RIVERSIDE DRIVE PROJECT DESIGN QUESTIONS

PEDESTRIAN AND BIKING DISCUSSION WisDOT Riverside Drive Project

4085-38-00
 Village of Allouez, Riverside Drive
 WIS 57
 Brown County

Bicycle Accommodations October 8, 2014

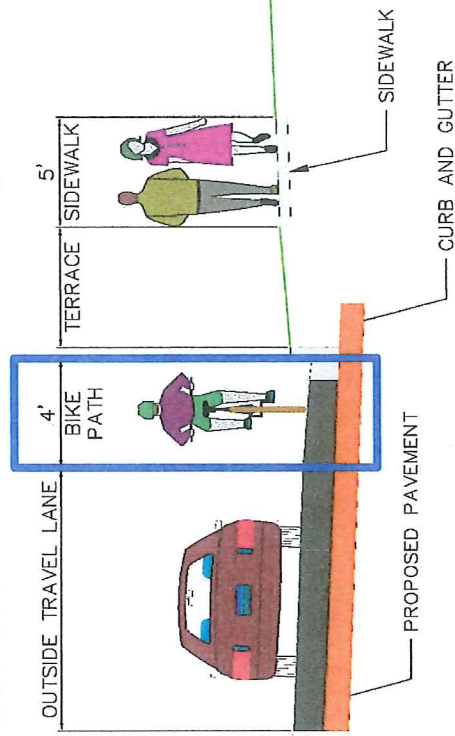
2. Include bike lanes (4 ft wide) in project. The state budget funding may impact this decision. If bike lanes remain in project this helps lower vehicle speeds. If bike lanes deleted roadway will probably stay the same width. *See page 4.*
